Project	IEEE 802.16 Broadband Wireless Access Working Group < http://ieee802.org/16 >	
Title	Corrections for downlink STC in OFDMA PHY	
Date Submitted	2005-01-26	
Source(s)	Yuval Lomnitz Yigal Eliaspur Intel.	Yuval.Lomnitz@intel.com Yigal.Eliaspur@intel.com
	Yigal Leiba Yossi Segal Runcom Ltd.	yigall@runcom.co.il yosis@runcom.co.il
Re:	IEEE P802.16REVd/D5-2004	
Abstract	Corrections and clarifications of definitions for STC in OFDMA PHY.	
Purpose	Adopt changes.	
Notice	This document has been prepared to assist IEEE 802.16. It is offered as a basis for discussion and is not binding on the contributing individual(s) or organization(s). The material in this document is subject to change in form and content after further study. The contributor(s) reserve(s) the right to add, amend or withdraw material contained herein.	
Release	The contributor grants a free, irrevocable license to the IEEE to incorporate material contained in this contribution, and any modifications thereof, in the creation of an IEEE Standards publication; to copyright in the IEEE's name any IEEE Standards publication even though it may include portions of this contribution; and at the IEEE's sole discretion to permit

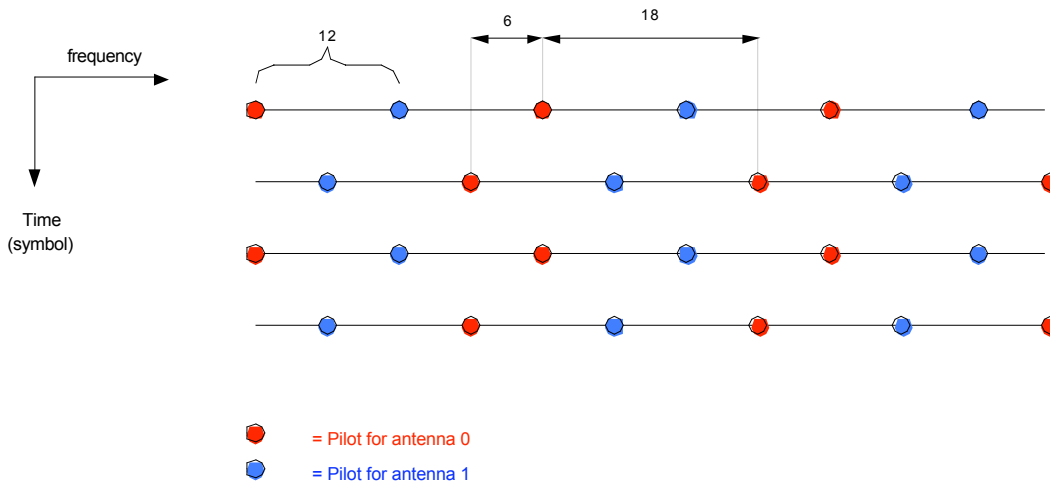
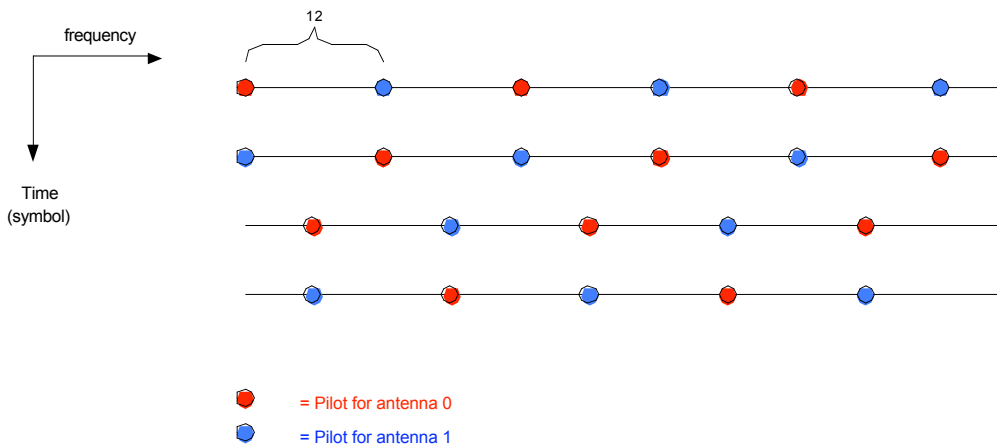
Equation (106) in section 8.4.6.1.2.2 (Symbol Structure for FUSC) defines that FUSC variable pilots are shifted by 6 in each odd symbol. However in STC this creates a problem:

1. Shifting the pilots changes the location of data subcarriers, resulting in the fact that the STC doesn't operate on QAM symbols transmitted in the same frequency. This makes STC combining complex and suboptimal.
2. The operation of STC coding is defined as exchanging tones with the same index for two OFDMA symbols. The STC operation is not well defined when data tones change their locations.
3. The movement of the pilots creates an irregular pilot pattern that doesn't improve channel estimation, as depicted below. It seems that the original intention was merely to exchange pilot-sets between the antennas.

On the other hand, canceling the movement of the pilot will result in regular structure, but will degrade the channel estimation performance (12 tone separation @11Khz carrier spacing = limited to 7us delay spread).

So our proposal is to define that pilot movement is every 2nd symbol.

The maximum pilot spacing over 2 OFDMA symbols is 18 tones (and the minimum is 6 tones)

The pilot spacing (from one antenna) in two OFDMA symbols is 12 tones.

In STC transmission the *FUSC_SymbolNumber* in equation (106) is replaced with $\text{floor}(FUSC_SymbolNumber/2)$, so that variable pilots shall move every 2nd symbol.

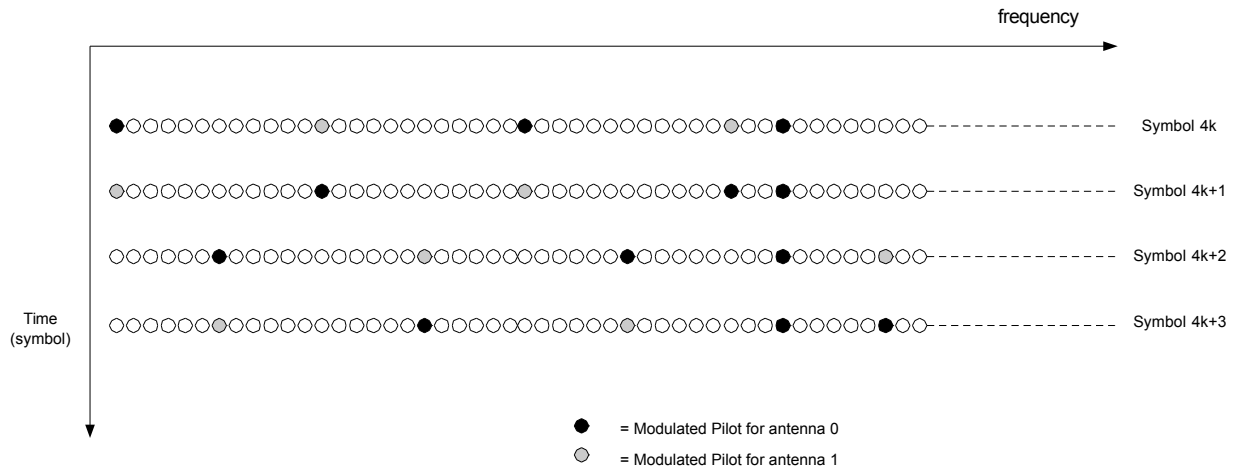
[Add the following text after line 49 in p.583]

STC rate 1 encoding shall be performed after constellation mapping and before subcarrier randomization defined in 8.4.9.4.1. s_1 and s_2 represent two subcarriers at the same frequency in two consecutive OFDMA symbols (each OFDMA subcarrier is referred to as a channel use). The STC rate 1 coding is done on all data subcarriers that belong to an STC coded burst in the two OFDMA symbols. Pilot subcarriers are not encoded and are transmitted from either antenna 0 or antenna 1.

Figure 251: STC usage with FUSC for 4 antenna configuration

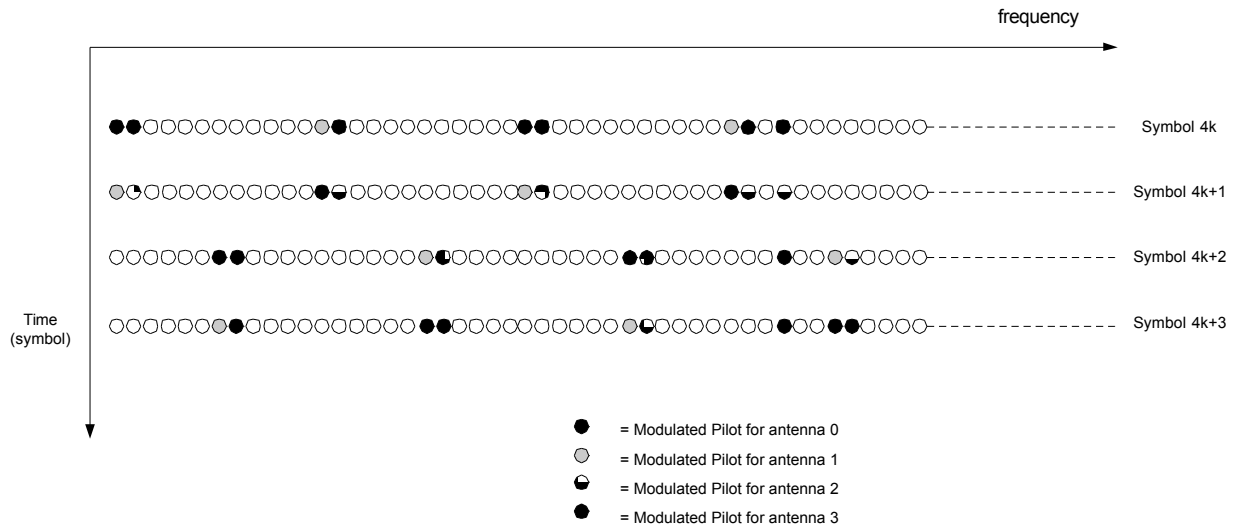
[Add figure 251a for illustration]

Even Symbols 0 : antenna 0 uses VariableSet#0 and ConstantSet#0, antenna 1 uses VariableSet#1 and Constant-Set#1, **antenna 2 uses indices of (VariableSet#0+1), antenna 3 uses indices of (VariableSet#1+1)**

Odd Symbols 1 : antenna 0 uses VariableSet#1 and ConstantSet#0, antenna 1 uses VariableSet#0 and Constant-Set#1, **antenna 2 uses indices of (VariableSet#1+1) and (ConstantSet#0), antenna 3 uses indices of (VariableSet#0+1) and (Constant-Set#1)**

The FUSC permutation is performed on the data subcarriers remaining after allocating the pilots for antennas 0,1 and the Constant pilots. The data subcarriers which overlap with variable pilots allocated to antennas 2,3 are punctured.
